APPLICATION FOR PERMISSION
UNDER SECTION 16 OF
THE TOWN PLANNING ORDINANCE
(CAP. 131)

For Official Use Only 請勿填寫此欄	Application No. 申請編號	A/TL-KN/1020
	Date Received 收到日期	24 MAY 2024

A/YL-KTN/1020
回應規劃署的提問

A/YL-KTN/1020

雨水排放建議圖

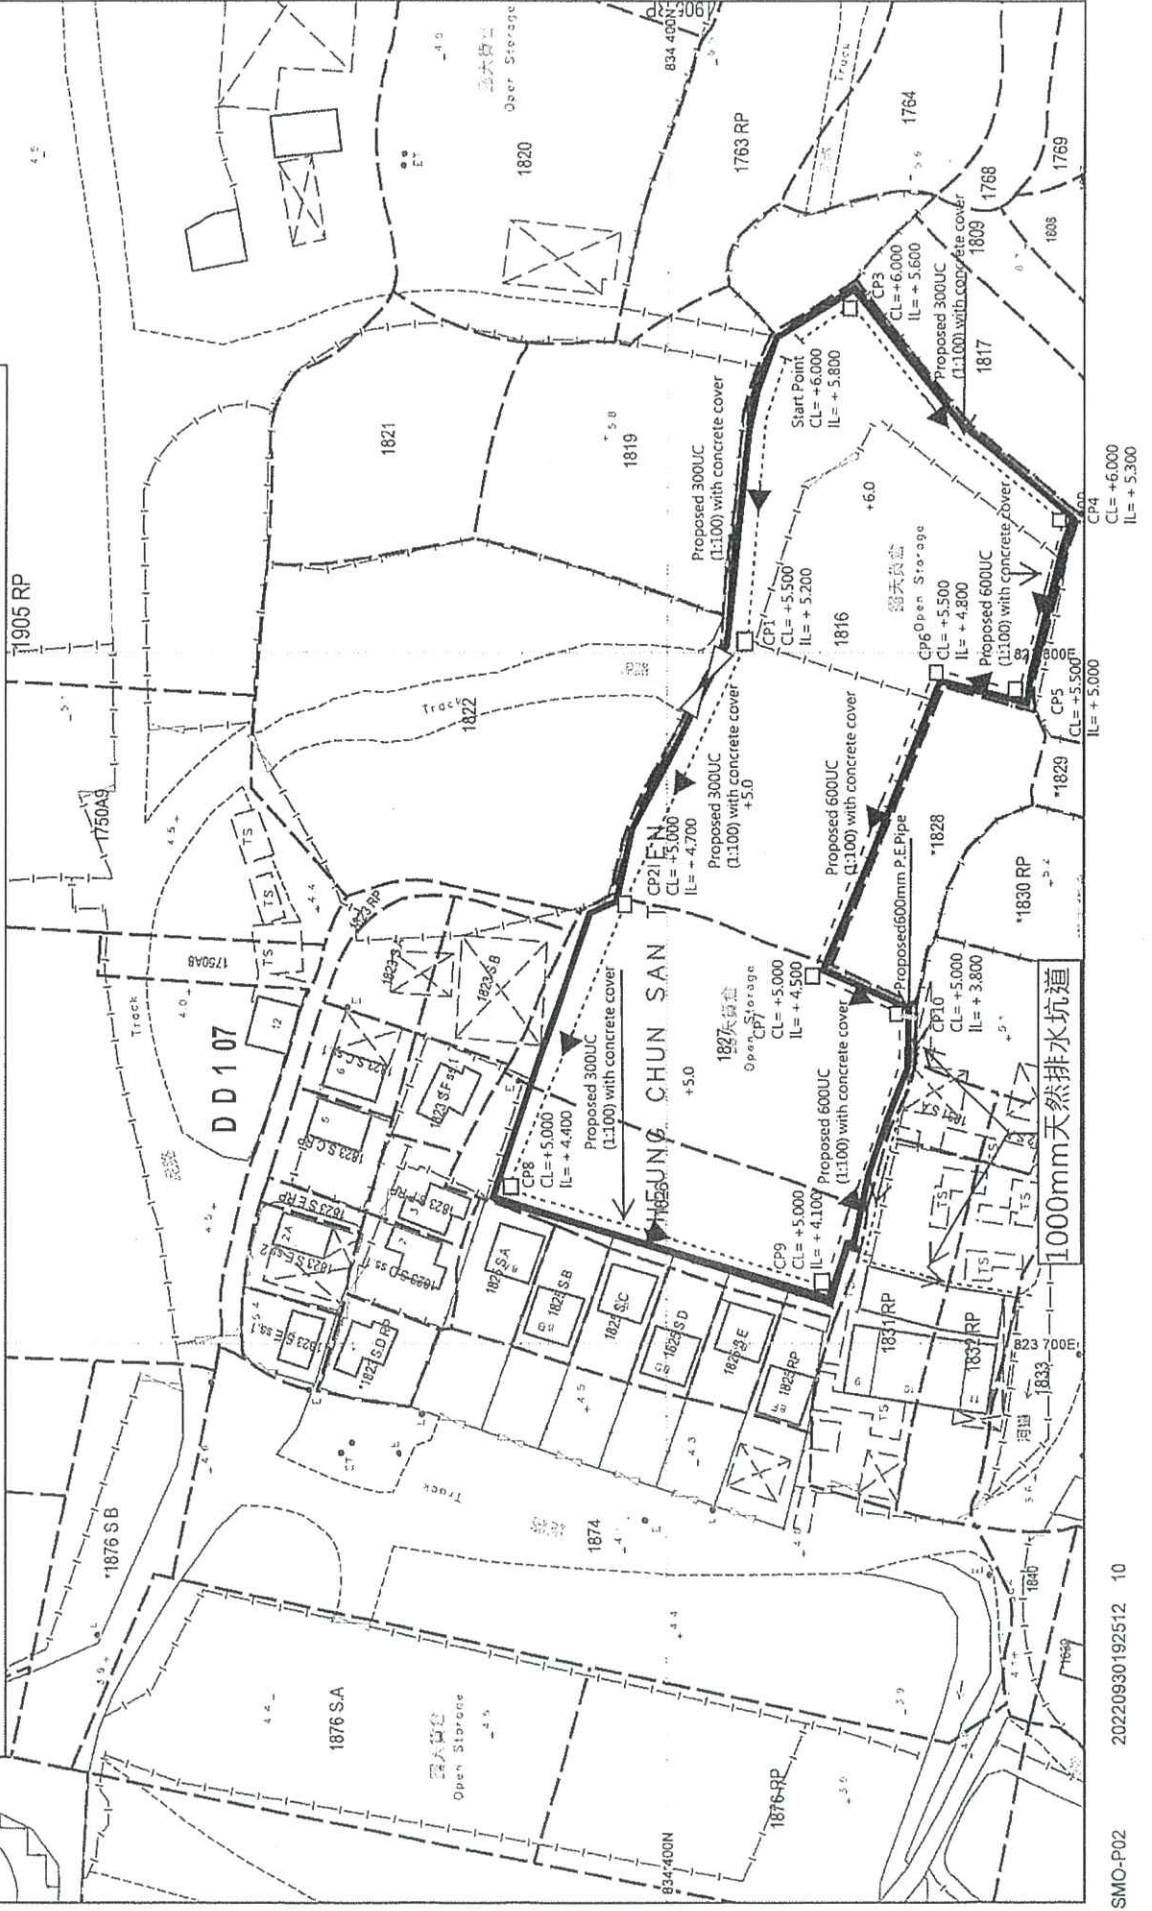
- (b) Please demonstrate with hydraulic calculations, with catchment plan, that all proposed/ existing drainage facilities are adequate to collect, convey and discharge the surface runoff accrued on the application site and to intercept the overland flow from the adjacent lands. 我等附上新一份排水建議圖內詳列有關計算及排水方案給貴署審議。

- (c) Please submit calculation demonstrating the downstream drainage system receiving the discharge from the development has adequate spare capacity to accommodate the runoff. 我等附上新一份排水建議圖內詳列有關計算及排水方案給貴署審議。

- (d) The proposal should indicate how the runoff (the flow direction) within the site would be discharged to the proposed u-channel. 我等附上新一份排水建議圖內詳列有關計算及排水方案給貴署審議。

- (j) Standard details should be provided to indicate the sectional details of the proposed u-channel and the catchpit. 我等附上新一份排水建議圖內詳列有關計算及排水方案給貴署審議。
- (k) Sand trap or provision alike should be provided before the collected runoff is discharged to the public drainage facilities. 我等設計的沙井全部設有沙坑。

圖 議 建 置 裝 防 消

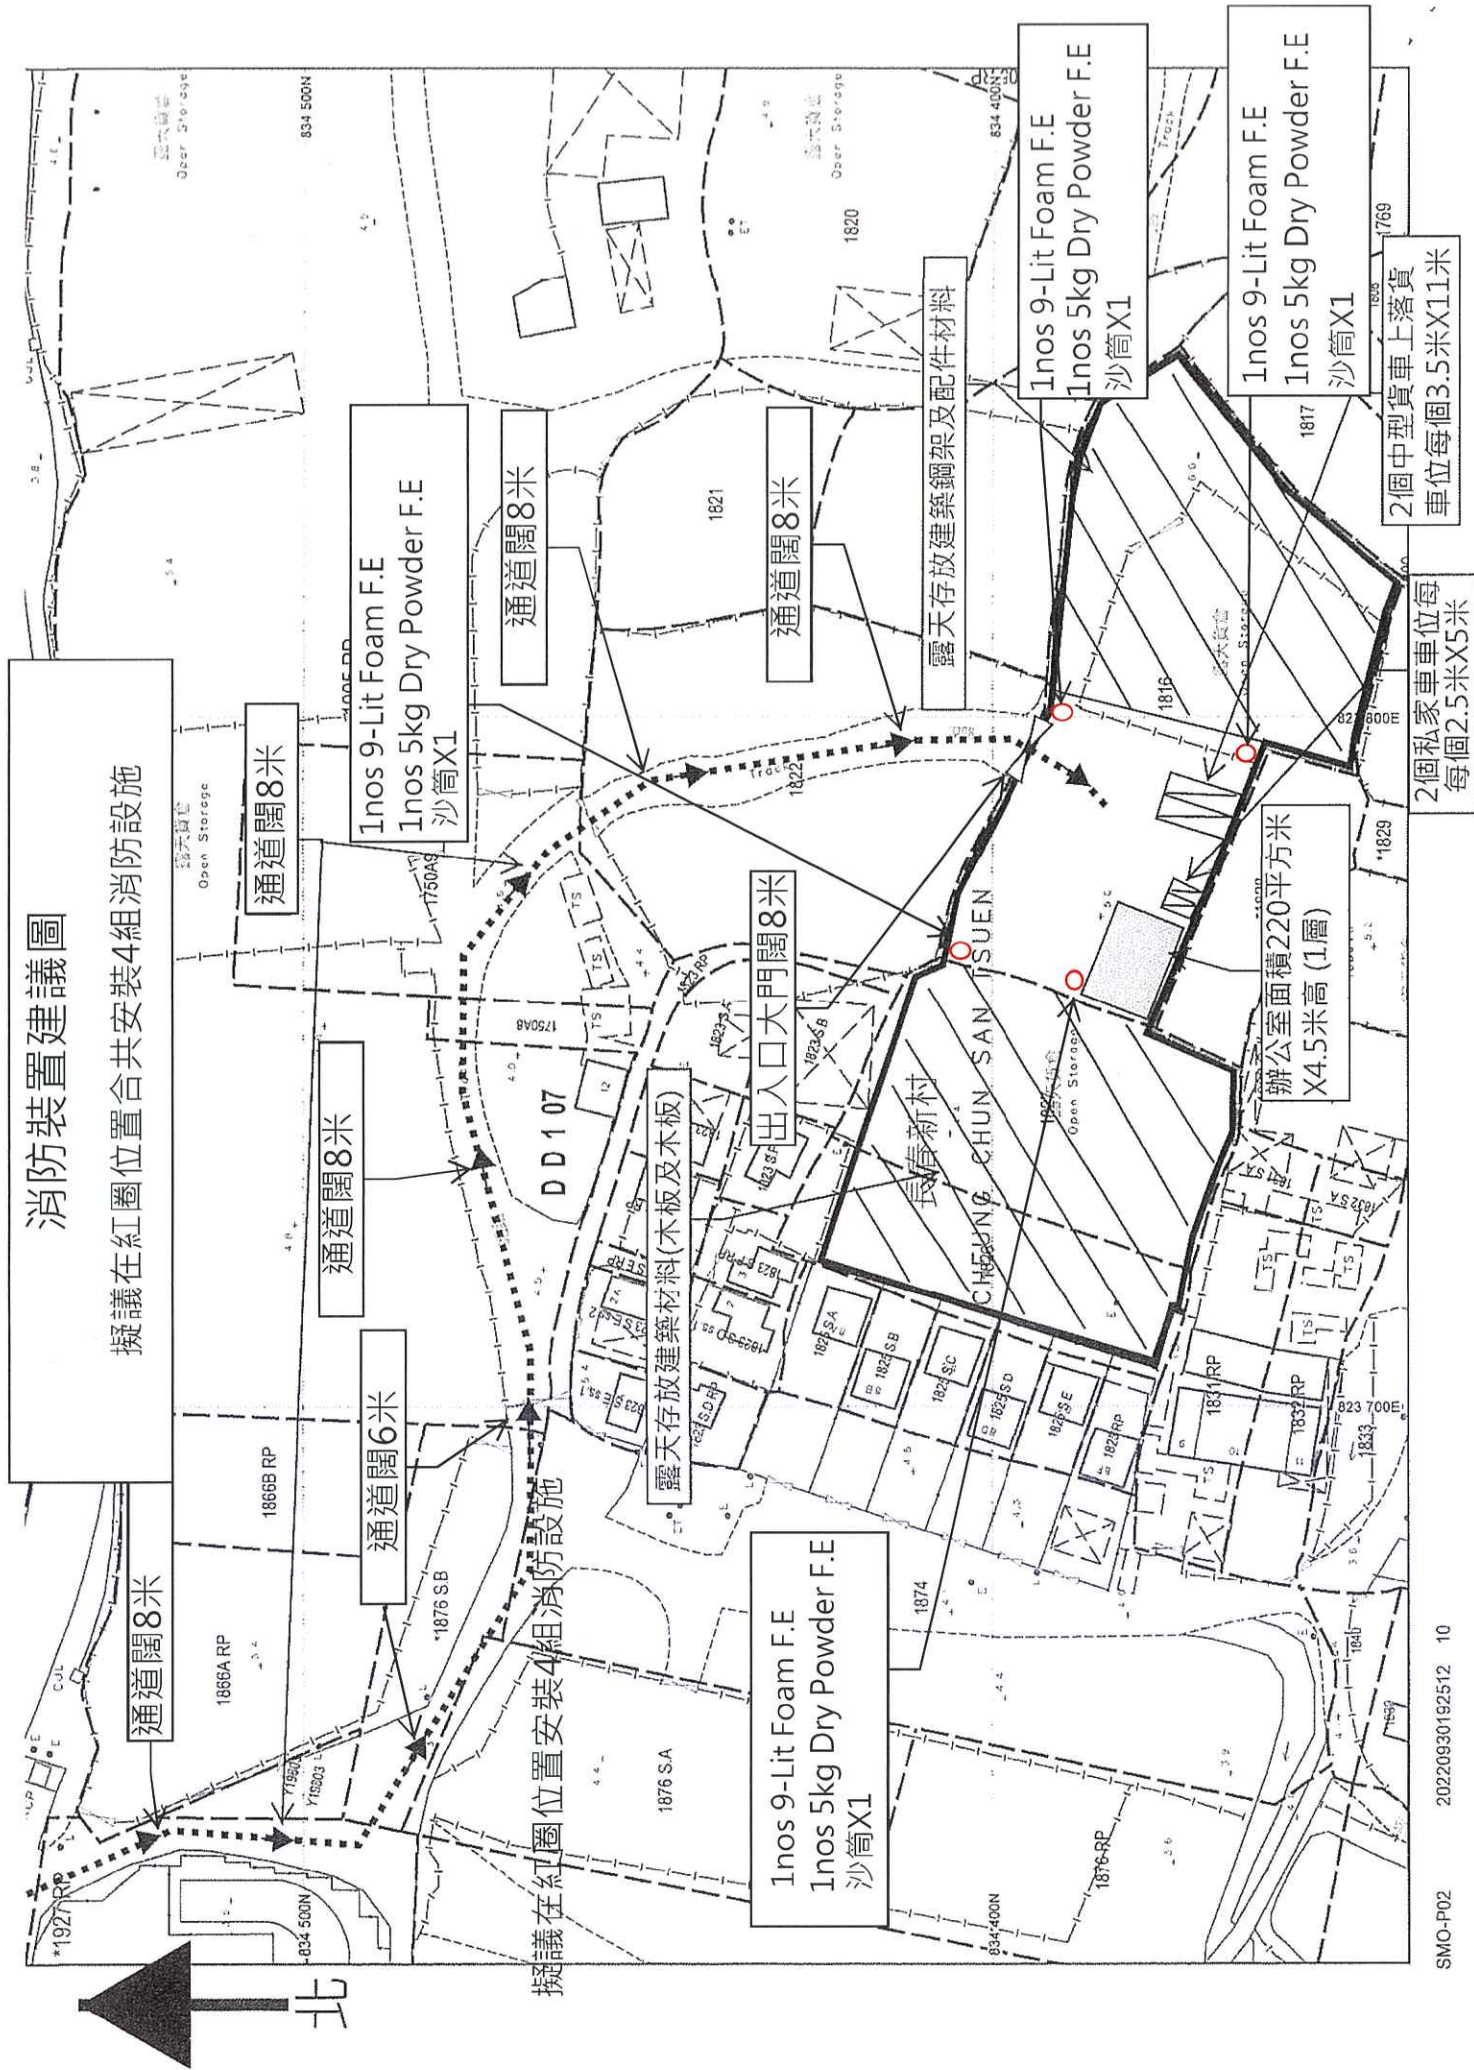
擬議在紅圈位置合共安裝4組消防設施

附圖相片 3

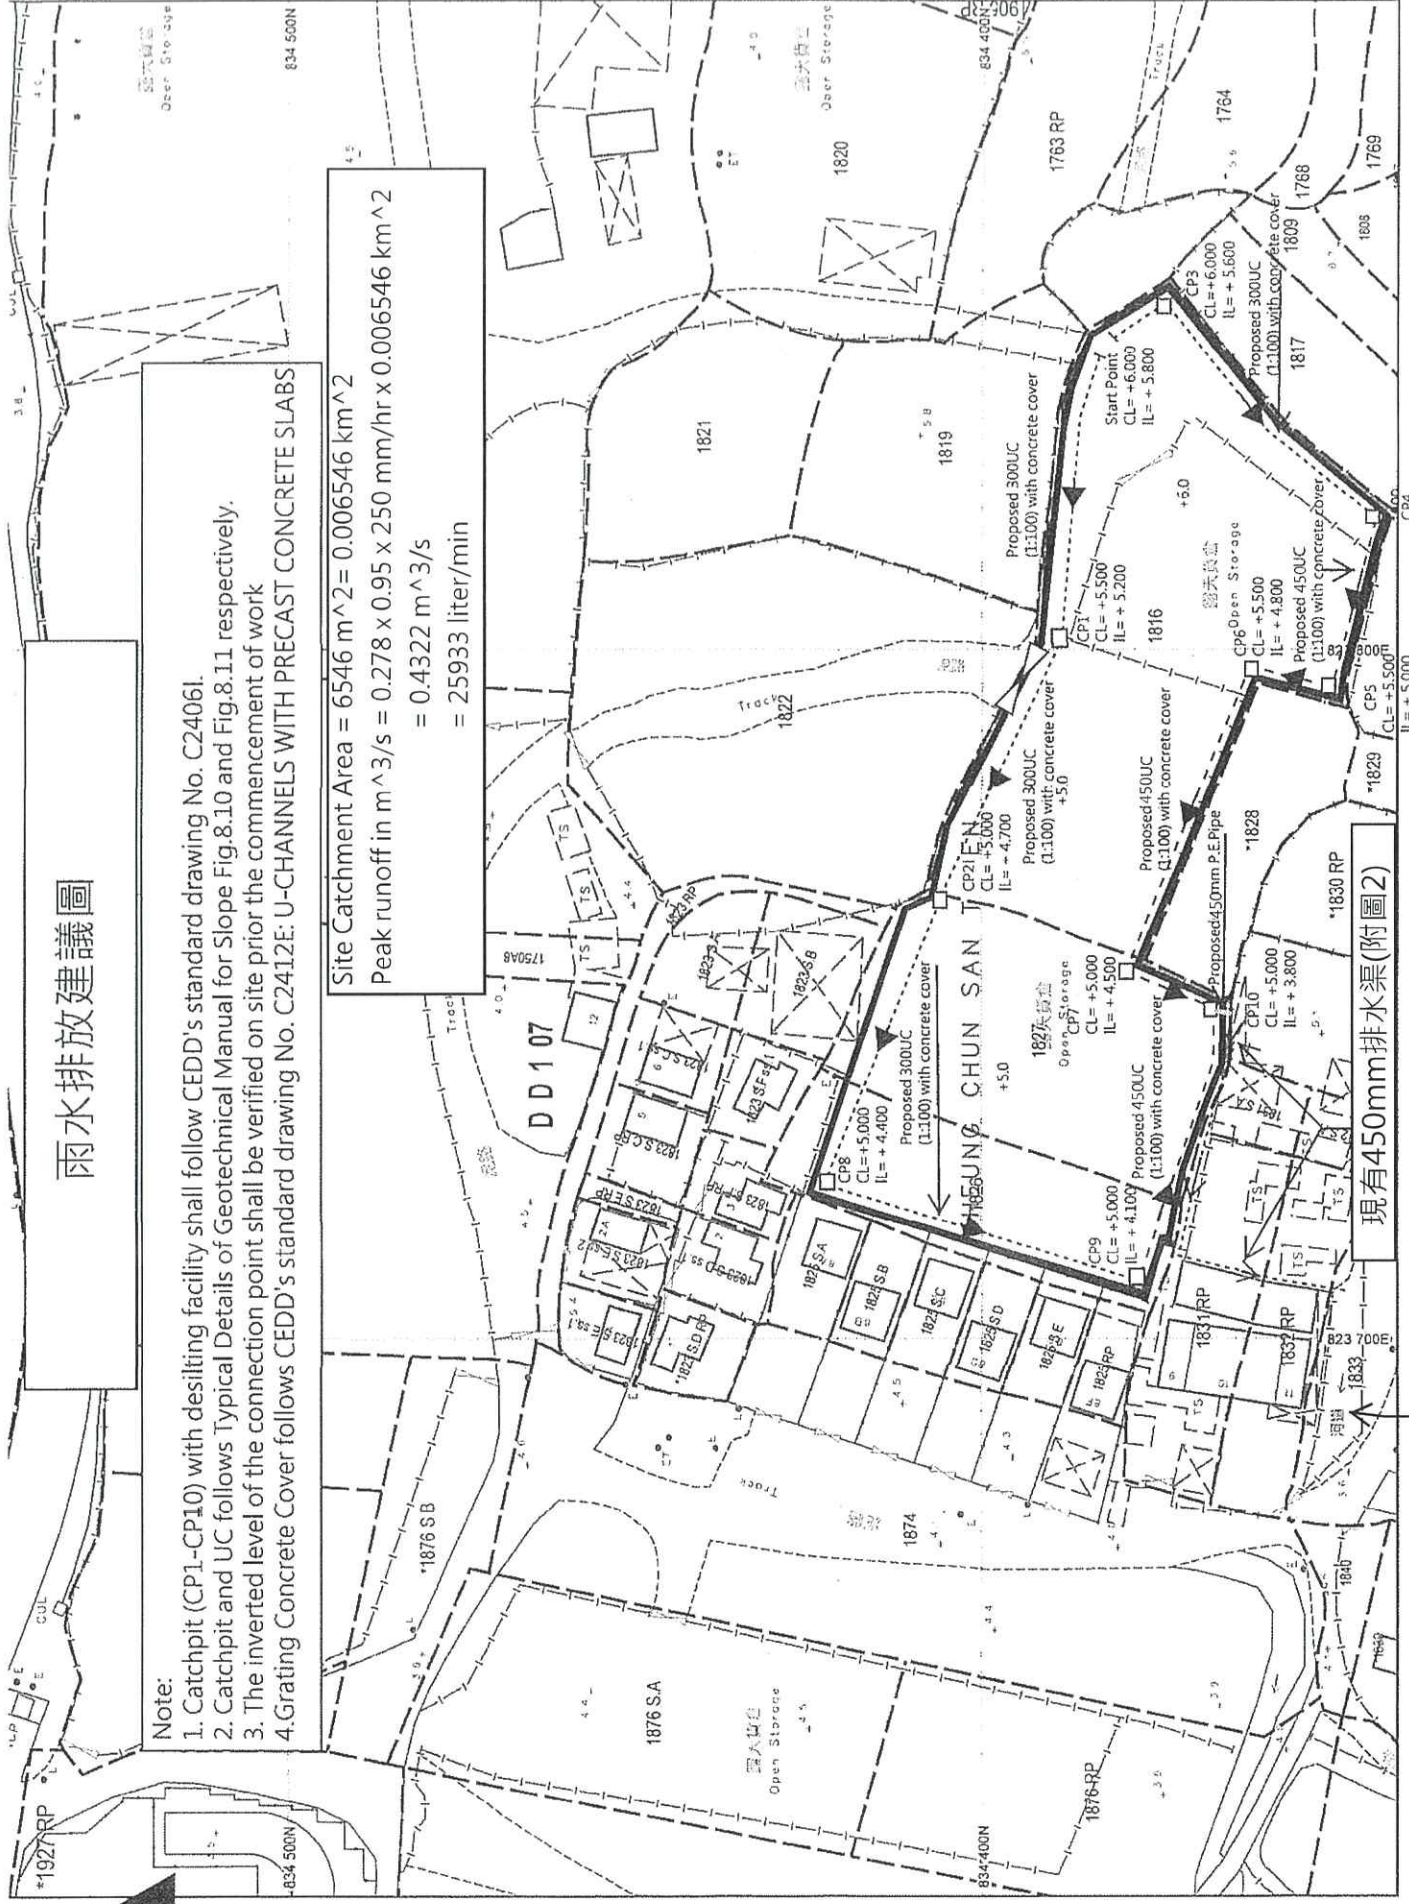
1. Viewing that the application site is in close proximity to residential dwellings, the applicant shall provide details of relevant mitigation measures to minimise the potential environmental nuisance in particular to the impacts of dust and noise to the surrounding environment;
有關申請地點西北面的住宅大部份閒置多時，主要為地產商多年前已購入大部份業權，之後一直空置，因上述地段為綜合發展區(1)等待日後發展，因此發展商沒有將上址出租，現場現時為十室九空的，(請看附圖相片 1)，我等會在西北面加設圍板及現時場地與村屋之間已有大樹分隔，因此對環境的影響非常輕微。(請看附圖相片 2)

2. The applicant shall provide details on types/substances of the 'wooden boards/metal frames/accessory materials' to be stored as well as the maximum height of any stacked-up materials at the application site; and
我等存放的物料為木板，木板，鋼通樑，及貨櫃箱改裝的臨時辦公室和儲物室，存放高度約為 5 米高(請看附圖相片 3)

A/YL-TKN/1020橫切面圖

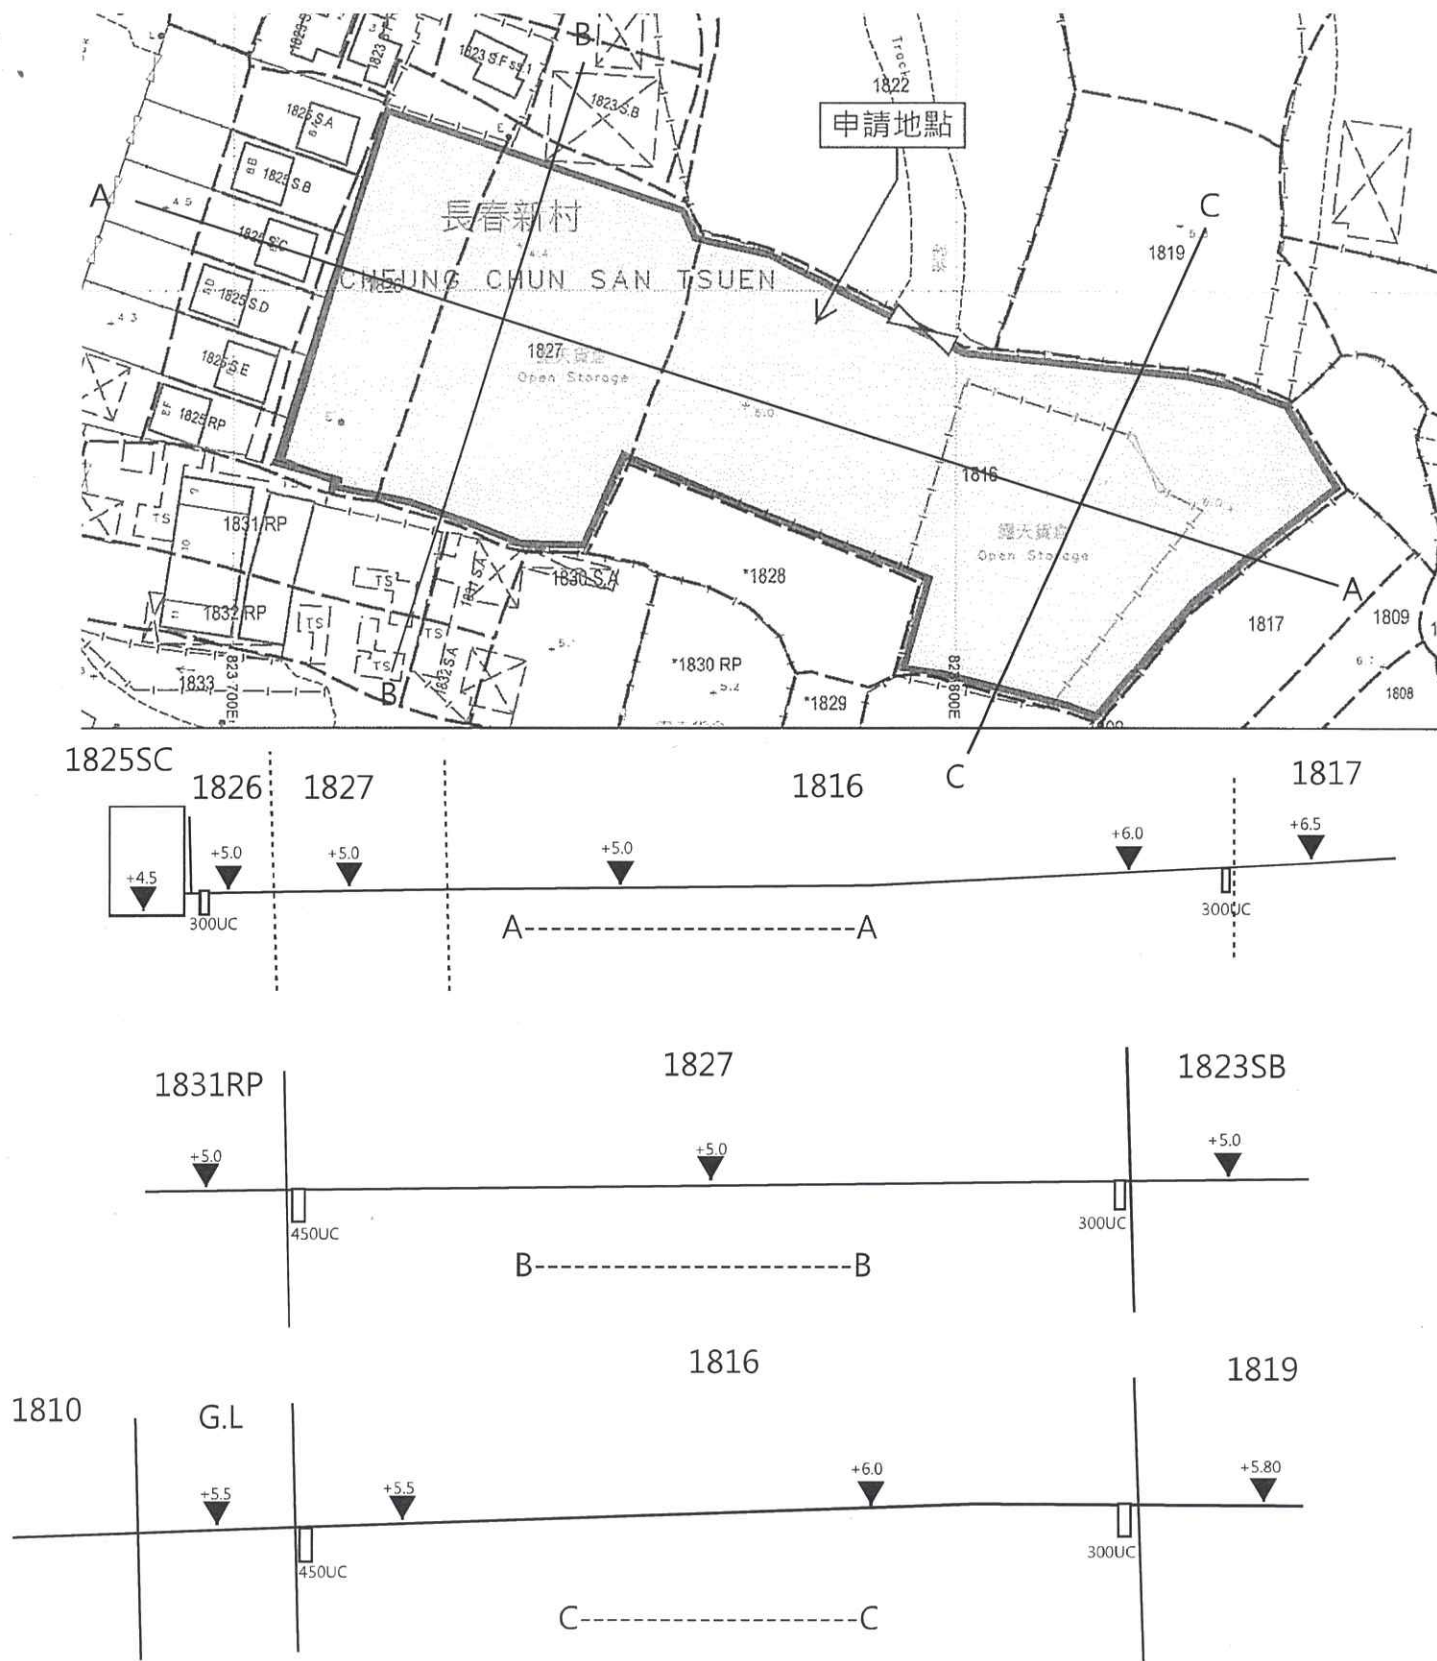
- (i) Cross sections showing the existing and proposed ground levels of the captioned site with respect to the adjacent areas should be given. 我等會連同此函一並附上橫切面圖給貴署參考
